**SUBJECT: BYRON STATION, UNITS 1 AND 2 - STAFF ASSESSMENT OF INFORMATION PROVIDED PURSUANT TO TITLE 10 OF THE *CODE OF FEDERAL REGULATIONS* PART 50, SECTION 50.54(f), SEISMIC HAZARD REEVALUATIONS FOR RECOMMENDATION 2.1 OF THE NEAR-TERM TASK FORCE REVIEW OF INSIGHTS FROM THE FUKUSHIMA DAI-ICHI ACCIDENT (CAC NOS. MF3884 AND MF3885)**

STAFF ASSESSMENT BY THE OFFICE OF NUCLEAR REACTOR REGULATION

RELATED TO SEISMIC HAZARD AND SCREENING REPORT

BYRON STATION, UNITS 1 AND 2

Figure 3.3-1 Plot of the Staff's and Licensee's Base Case Shear-Wave Velocity Profiles for the Byron site: a) entire profile, b) profile in upper 200 ft.

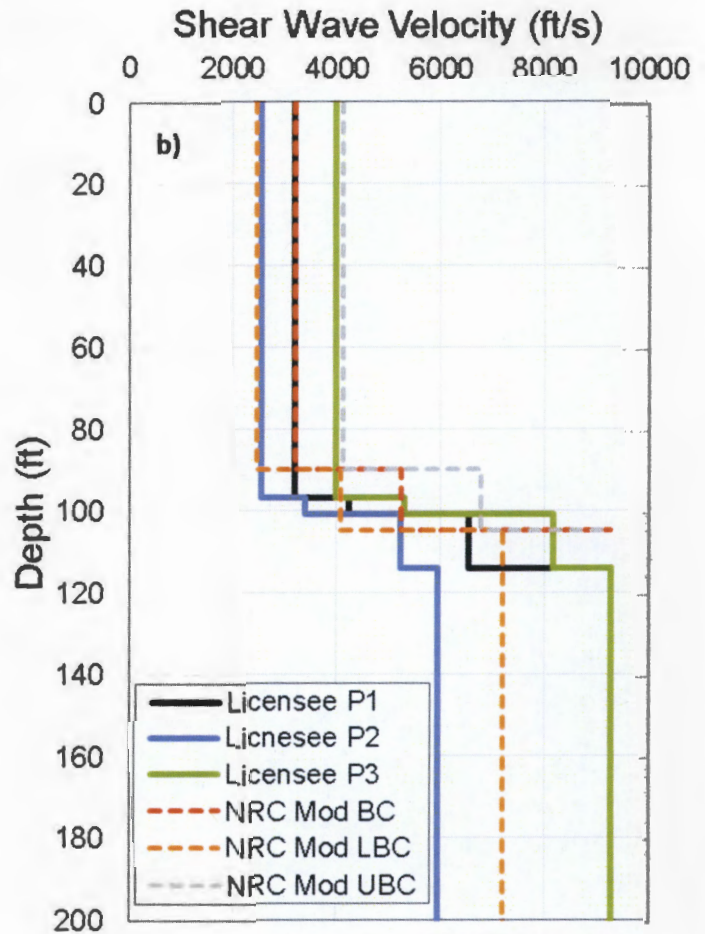
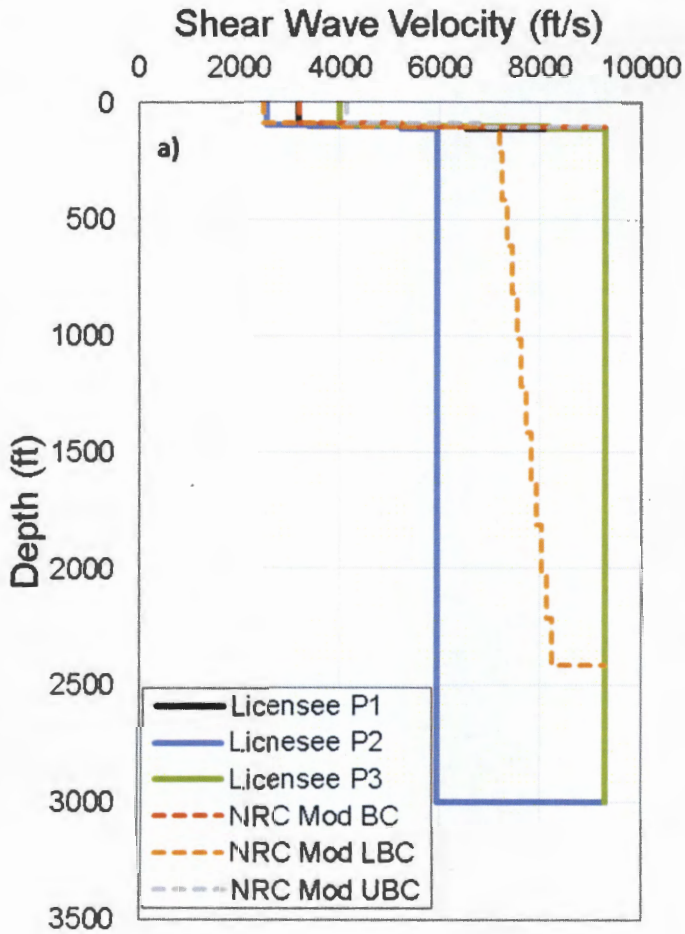
The licensee developed three base case shear-wave velocity profiles for the Byron site. The best estimate profile was developed using the measured shear wave velocities and consists of 114 ft. (44 m) of firm rock overlying hard bedrock. To develop the upper and lower cases, the licensee used a scale factor of 1.25 in the upper 114 ft. (44 m) and a factor of 1.57 below that depth. Table 2.3.2-1 and Figure 2.3.2-1 of the SHSR provide the licensee's shear-wave velocity profile for each of the three base cases. Figure 3.3-1 of this assessment shows the licensee's three shear-wave velocity base case profiles.

To perform its confirmatory analysis, the NRC staff utilized information from the Byron UFSAR to estimate the near surface shear wave velocity of the dolomite. As such, the NRC staff's best estimate base case profile is the same as the licensee's over the upper 90 ft. (27.4 m). Below this depth, the NRC staff's best case profile increases to an intermediate shear wave velocity of 5250 ft./sec (1600 m/s) until reaching base rock at a depth of 105 ft. (32 m). As a result of multiple near surface measurements, the NRC staff used a natural log standard deviation of 0.20 to estimate upper and lower base case velocity profiles. The NRC staff used assumed a linear increase in velocity with depth in the deeper layers for the lower base case velocity. Figure 3.3-1 of this assessment shows a comparison of the licensee's and NRC staff's three base case velocity profiles. As shown in Figure 3.3-1, the licensee's base case and upper profiles reach base rock at a depth of 114 ft. (35 m). The licensee's lower base case profile has a constant shear wave velocity of 5942 ft./sec from a depth of 114 ft. (35 m) to base rock at 3000 ft. (914 m).

Figure 3.3- 2 Plot Comparing the Staff's and the License's Median Amplification Functions and Uncertainties for Model 1, Profile 1 at two input loading levels for the Byron site: a) loading level of 0.1 g, b) loading level of 0.5 g.

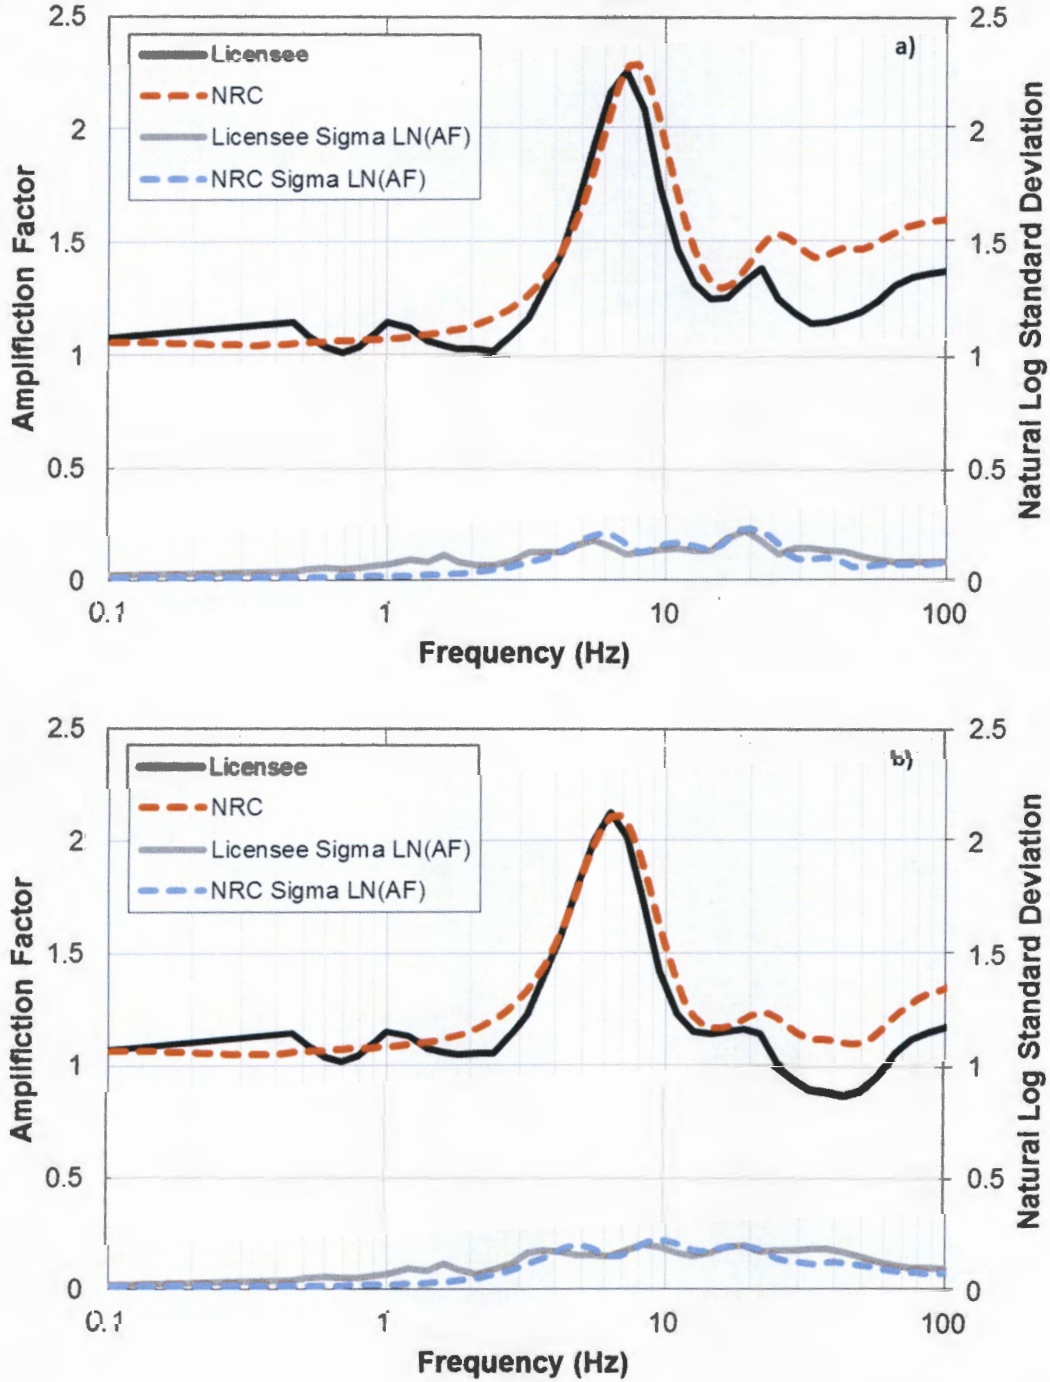
Figure 3.3-2 of this assessment shows a comparison of the staff's and licensee's median site amplification functions and uncertainties for the base case profile with EPRI rock curves at input loading levels of 0.1 g and 0.5 g. The licensee's and NRC staff's amplification functions are similar with minor to moderate differences in amplification above 20 Hz. This difference is due

primarily to differences in kappa used by the licensee and NRC staff. As shown in Figure 3.3-3, these differences do not substantially impact the control point hazard curves, which are very similar.

Overall, the licensee's approach to modeling the subsurface rock properties and uncertainty results in similar site amplification factors and standard deviation, as well as the control point seismic hazard curves. Because the licensee followed the guidance in the SPID for characterizing the site response inputs, these minor differences are acceptable to the NRC staff. Appendix B of the SPID provides guidance for performing site response analyses, including capturing the uncertainty for sites with less subsurface data; however, the guidance is neither entirely prescriptive nor comprehensive. As such, various approaches in performing site response analyses, including the modeling of uncertainty, are acceptable.

Figure 3.4-1 Comparison of the Staff's GMRS, Licensee's GMRS, SSE, and the IHS for the Byron site.

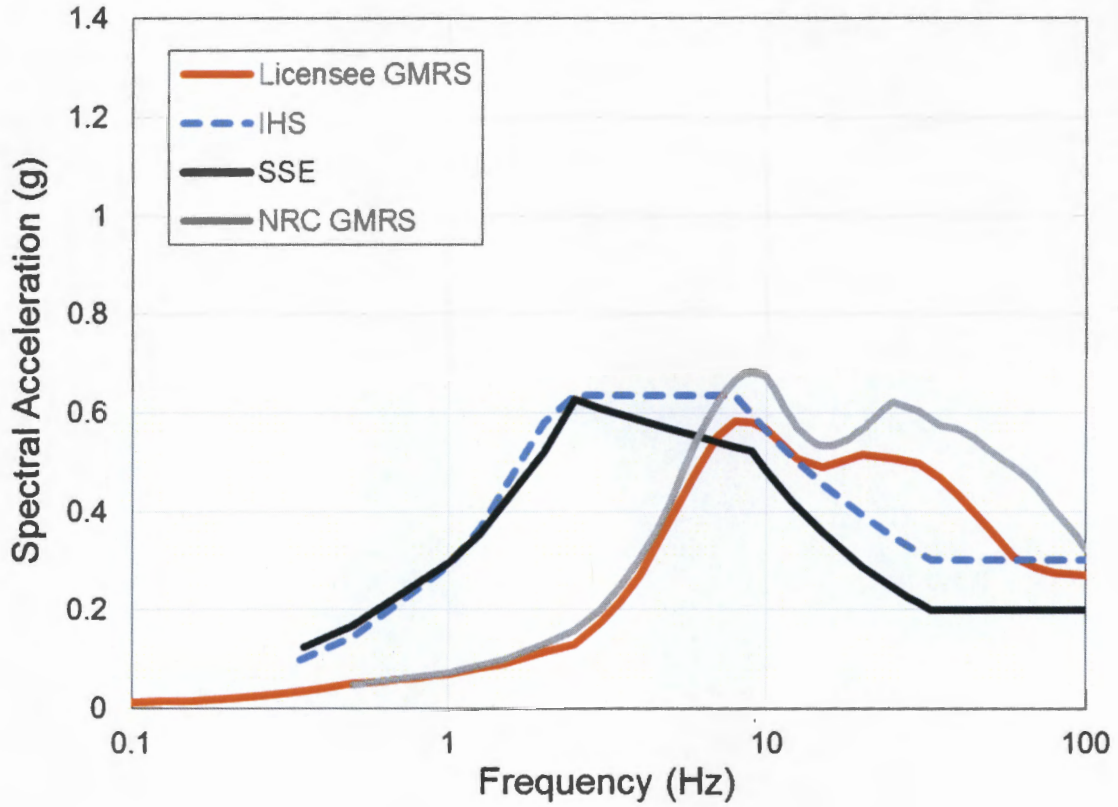
The NRC staff independently calculated the  $10^{-4}$  and  $10^{-5}$  UHRS using the results of its confirmatory PSHA and site response analyses, as described in Sections 3.2 and 3.3 of this staff assessment, respectively. Figure 3.4-1 of this assessment shows a comparison of the GMRS determined by the licensee to that determined by the NRC staff.

As shown in Figure 3.4-1, the licensee's GMRS shape is generally similar to that calculated by the NRC staff. However, NRC staff's confirmatory GMRS is somewhat higher than the licensee's at frequencies near 10 Hz and greater frequencies. As described above in Section 3.3, the NRC staff concludes that these minor differences over the higher frequency range are primarily due to the differences in the site response analyses performed by the licensee and NRC staff. The NRC staff concludes that these differences are acceptable because the licensee followed the guidance provided in the SPID with respect to both the PSHA and site response analysis for the Byron site.

The NRC staff confirms that the licensee used the present-day guidance and methodology outlined in RG 1.208 and the SPID to calculate the horizontal GMRS, as requested in the 50.54(f) letter. The NRC staff performed both a PSHA and site response confirmatory analysis and achieved results consistent with the licensee's horizontal GMRS. As such, the NRC staff concludes that the GMRS determined by the licensee adequately characterizing the reevaluated hazard for the Byron site. Therefore, this GMRS is suitable for use in subsequent evaluations and confirmations, as needed, for the response to the 50.54(f) letter.
